GUAM POWER AUTHORITY

AMENDMENT NO.: II

INVITATION TO BID NO.: GPA-050-22

PITI NO. 7 FIRE PROTECTION UPGRADE AND SMOKE ALARM SYSTEM (DESIGN BUILD)

ATTACHMENT A.

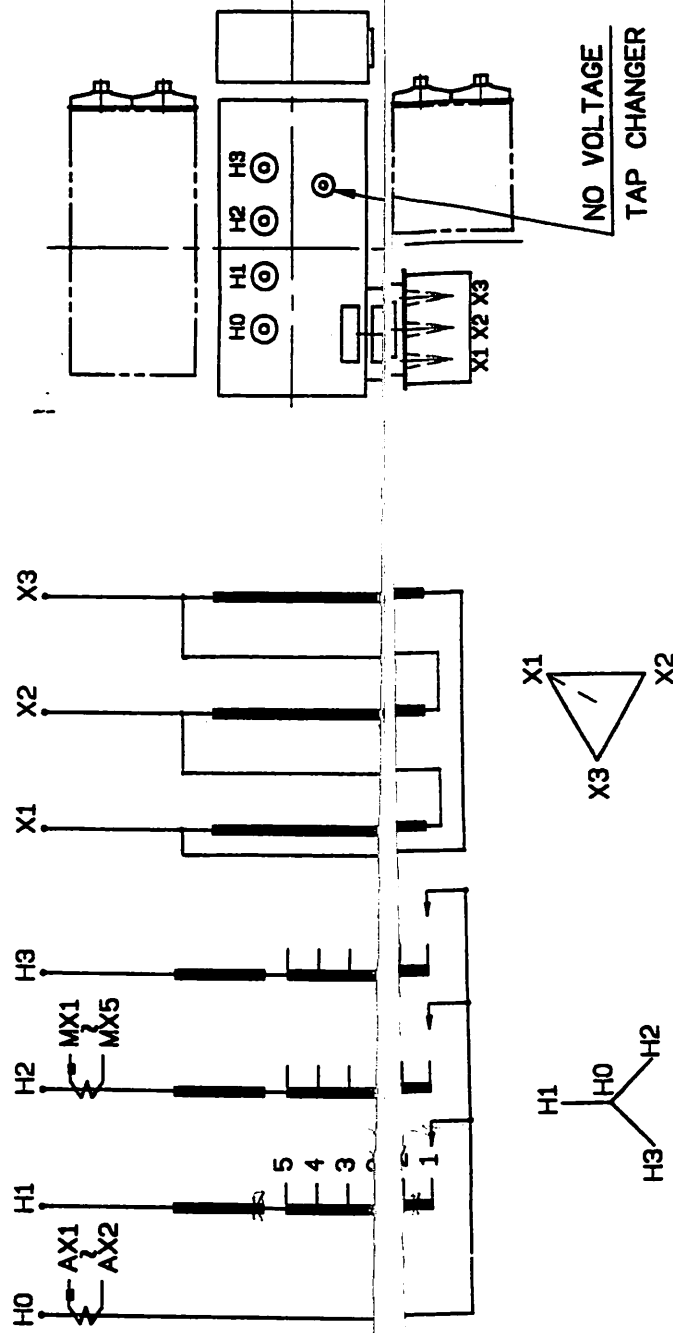
1. Is the outdoor transformer an oil-insulated type? If yes, please confirm the oil capacity in terms of gallons.

Yes, 3,567 gallons. Kindly refer to Attachment A. (see attached)
